RE: Churchill Marine Observatory, Environment Act Proposal
File number: 5803.00
Response to Request for Additional Information

On behalf of the University of Manitoba, KGS Group has prepared this response to your request for additional information and to update you on proposed project changes from the Environment Act Proposal (EAP) submitted November 9, 2015 for licencing approval to construct and operate the Churchill Marine Observatory (CMO). Proposed changes from the EAP and responses to the two (2) items identified in your email dated January 13, 2016 are provided in the paragraphs below. This information is being provided for inclusion in the project file and so that you can continue processing the proposal. Supporting information is enclosed with this letter, when necessary, as identified in the following paragraphs.

SITE LOCATION PLAN

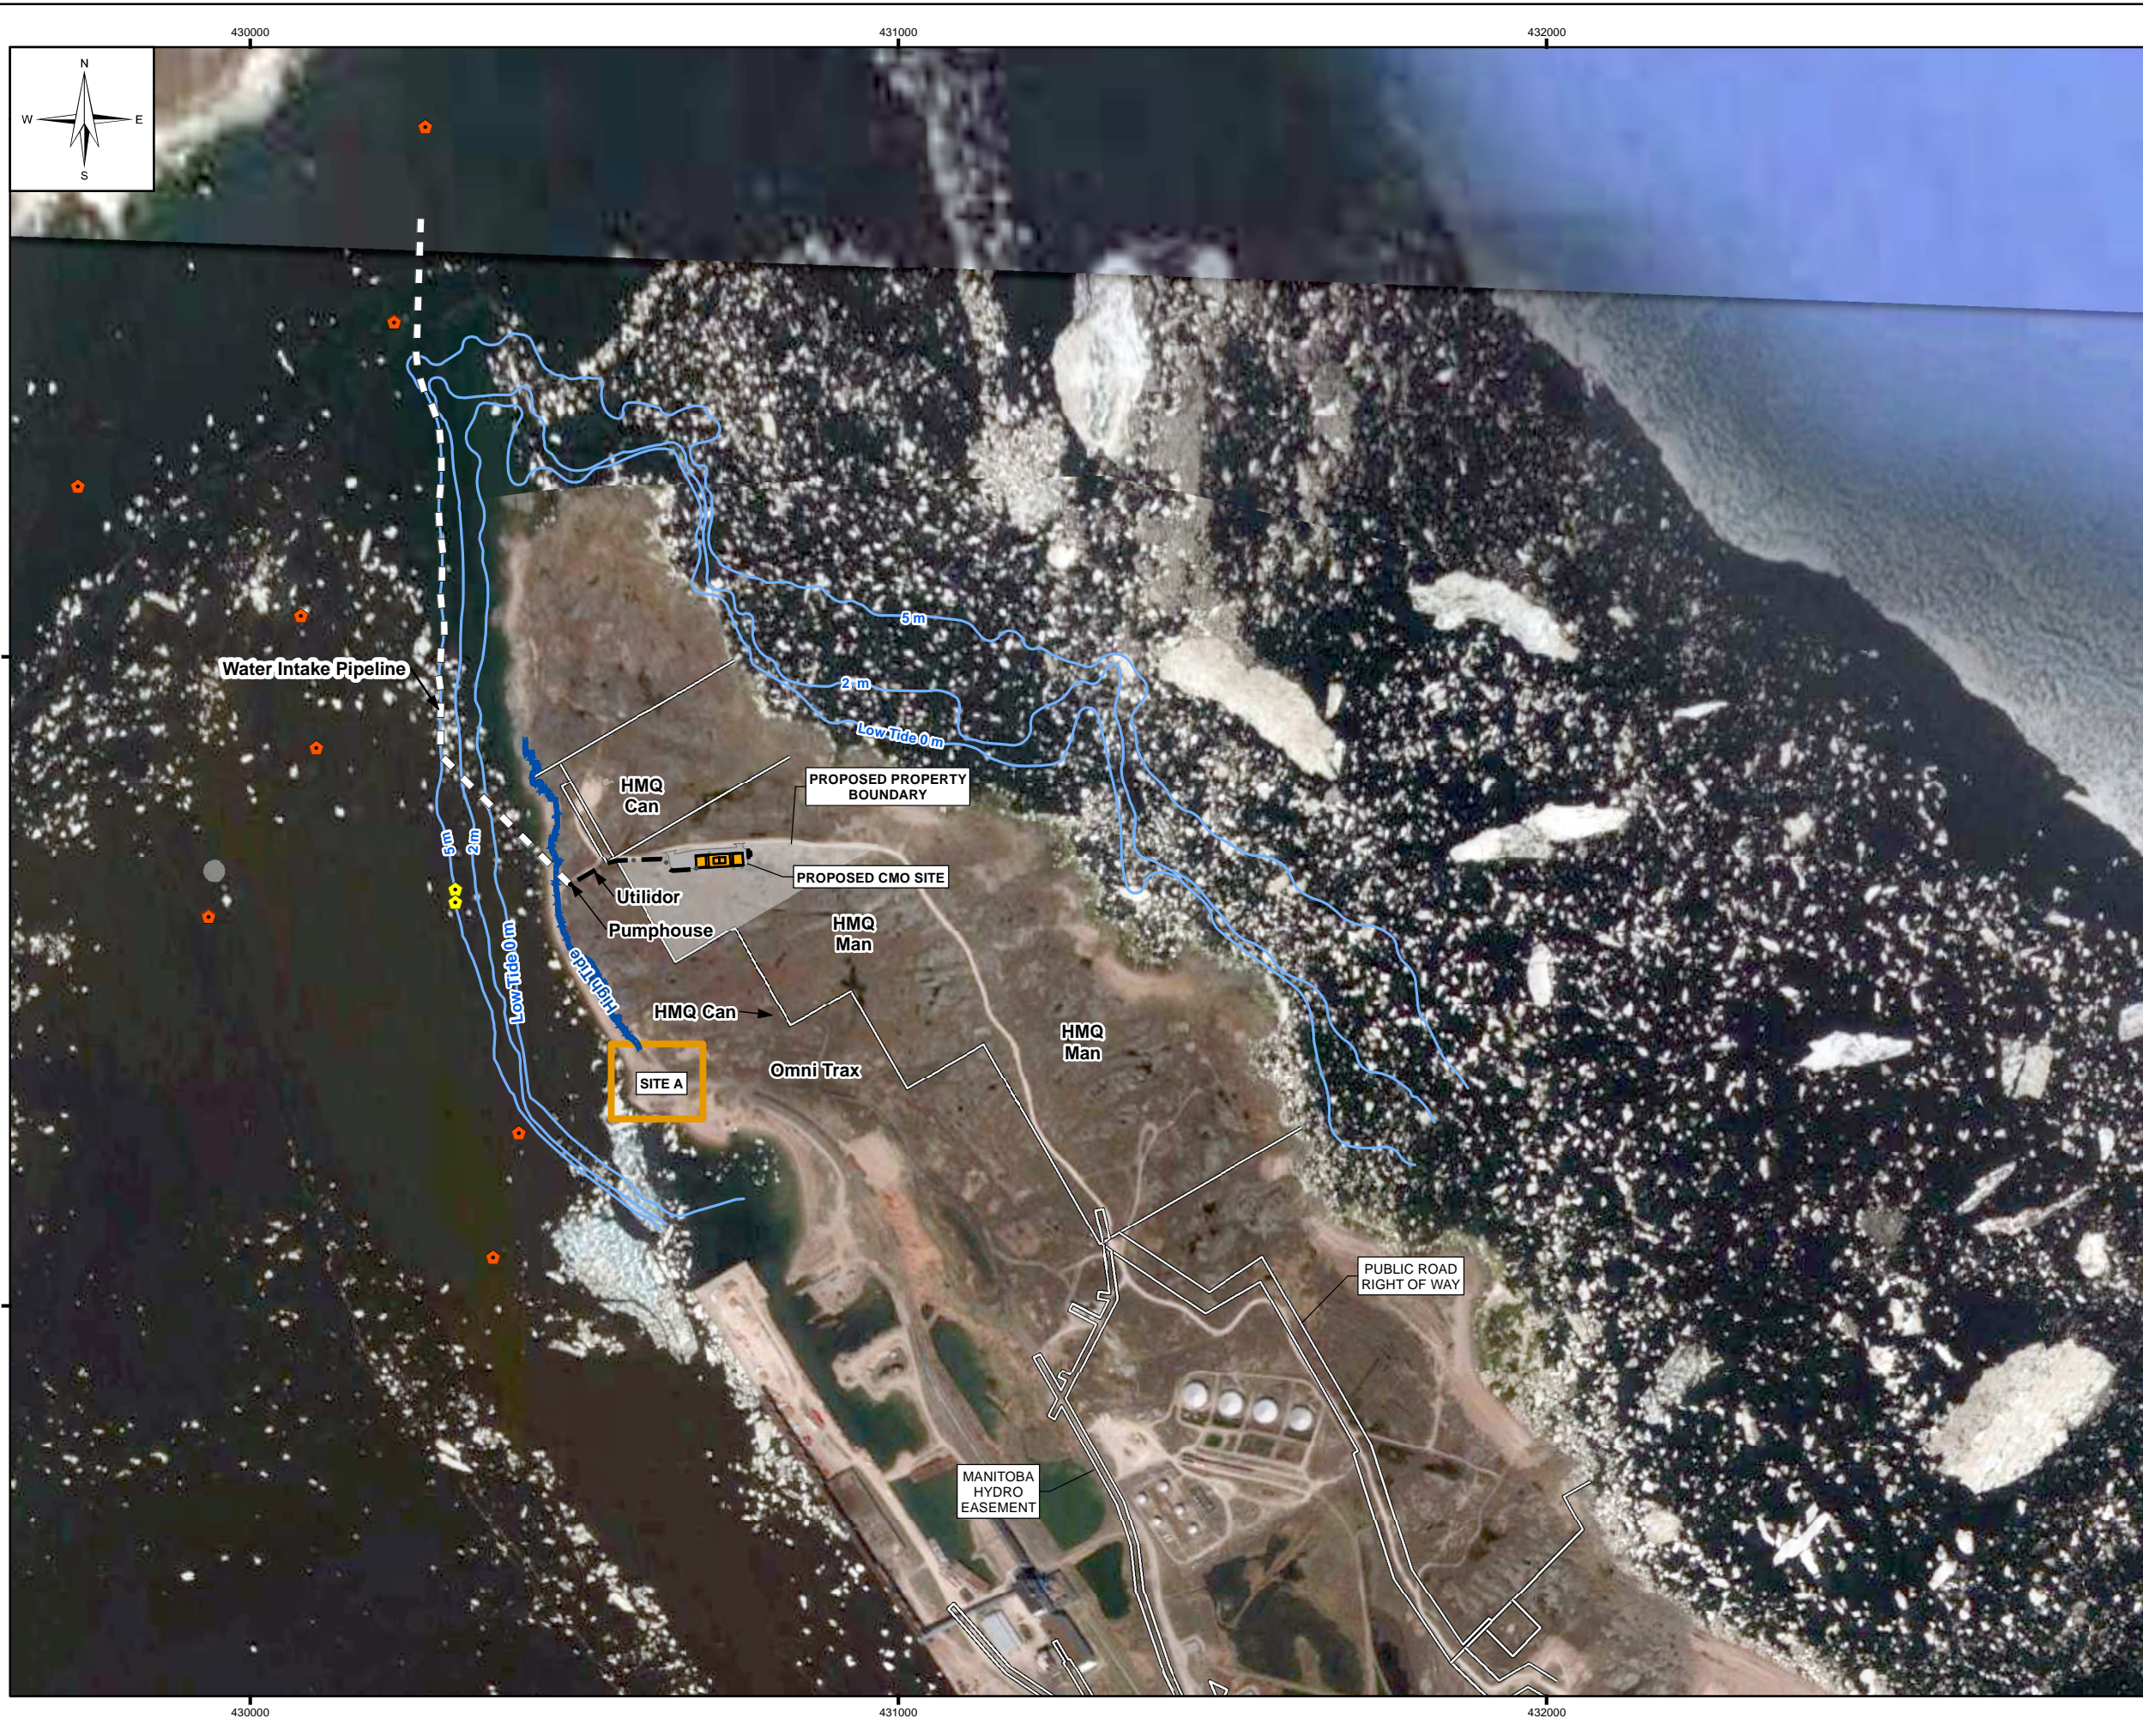
Since the EAP was submitted the project design has been further advanced with access to the water and the site layout optimized to reduce construction costs and decrease the already limited potential adverse effects. Additionally since the EAP was submitted an alternative route for the utilidor and water intake pipe (with pump house) is being investigated in the event an agreement cannot be reached with Omni Trax to cross their land as originally proposed. This route has not been detailed yet or shown in the enclosed figures but it would run across the Parks Canada land north adjacent the CMO site and down to the shoreline north of the Omni Trax property.

Access to the water in the original EAP consisted of a boat ramp and a seasonal dock to be installed west of the main development site on the cobble beach shore of the Churchill River. The permanent concrete boat ramp was proposed to be approximately 4 m wide and long enough to allow launching of the 9 m research boat during high tide and potentially the upper range of the tide cycle. As noted in the EAP alternative non-permanent ramp options were still being investigated and that is what is now being proposed. A custom designed trailer with large radius and wider wheels, and multiple axles that would reduce the load on the river and beach

bottom, is being investigated. The trailer will be pushed into or pulled out of the water using a four wheel drive truck. If, however, slippage on the wet and smooth rocks proves to be problematic to generate enough force to overcome the unevenness of the shore and any sinking of the trailer wheels into the beach gravel a winch system can be anchored to the bedrock above the high tide. The winch could also be used to launch the trailer using a pulley fastened to one of the two buoys off shore.

The dock was proposed to be installed seasonally at the shore and consist of a structural gangplank approximately 40 m long anchored on the shore and connected to a floating section extending approximately 12 m into the estuary at low tide in order to accommodate the research boat. In place of the seasonal dock boats are now proposed to be moored at the buoys located off shore, with a water depth of 5 m at low tide, as shown in the revised Figure 1. When personnel or material are to be transferred to and from shore, a smaller boat would be taken from shore to resupply the boat docked at the buoy. The boat launch system described above would also be used to launch this smaller boat. The buoys will be designed according to Transport Canada's "An Owner's Guide to Private Buoys" and the Canadian Coast Guard "Canadian Aids to Navigation CANS 2011" to ensure compliance with the *Canada Shipping Act*. Approval for these buoys is currently in process with the Navigation Protection Program.
